Re: MMC Staff Parking Garage | 222 St. John Street | Level III Site Plan Design Change

The purpose of this memorandum is to summaraze changes made within the attached revised design drawings since the initial Level III Site Plan Submission on June 22, 2018.

North View

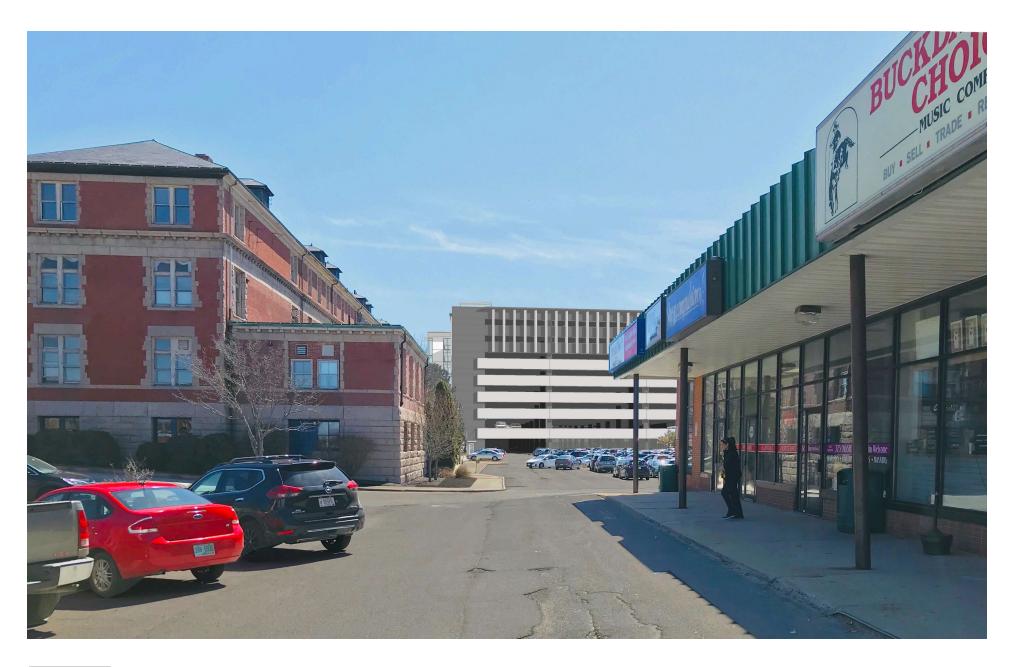
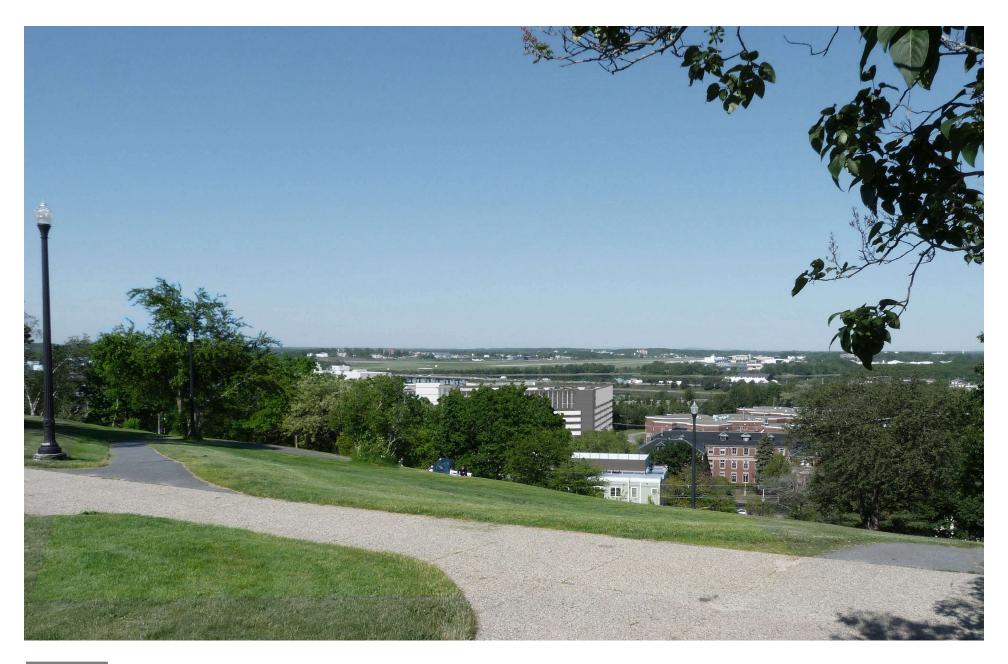
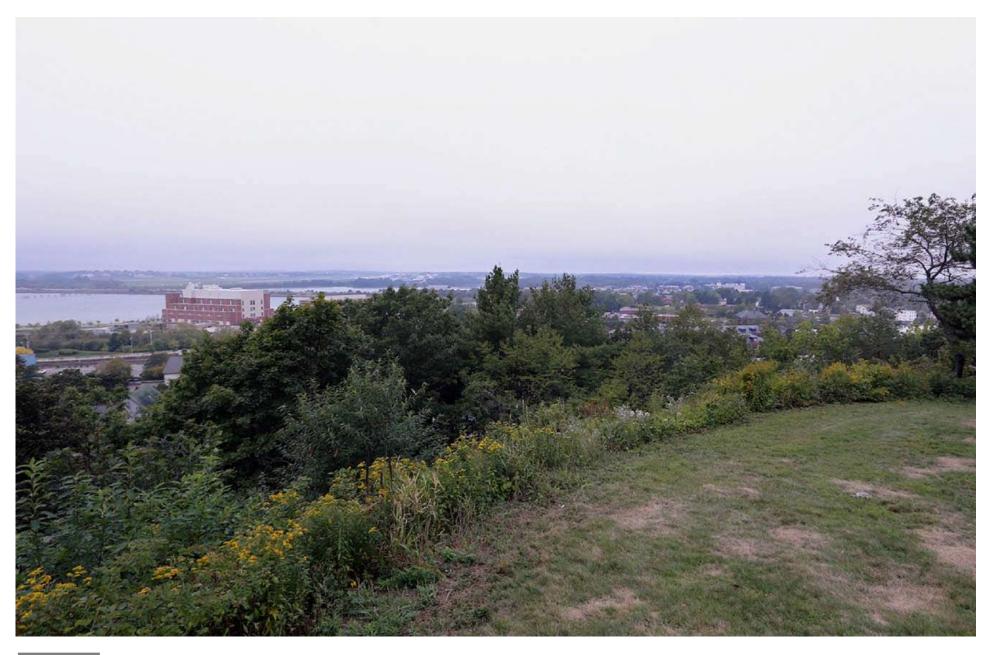
- Revised east façade to accommodate entrance for 184 St. John Street users (Eagles).
- Enlarged canopy over entrance area in response to City comments.
- Added windows at electrical / mechanical rooms in response to City comments.
- Reduced the floor to floor height of the first deck level (lower) by relocating van accessible spaces to level G; revision resulted in a reduction in the overall building height (revisions to elevation call outs)
- Removed the screening wall above the stair tower due to changes in mechanical equipment
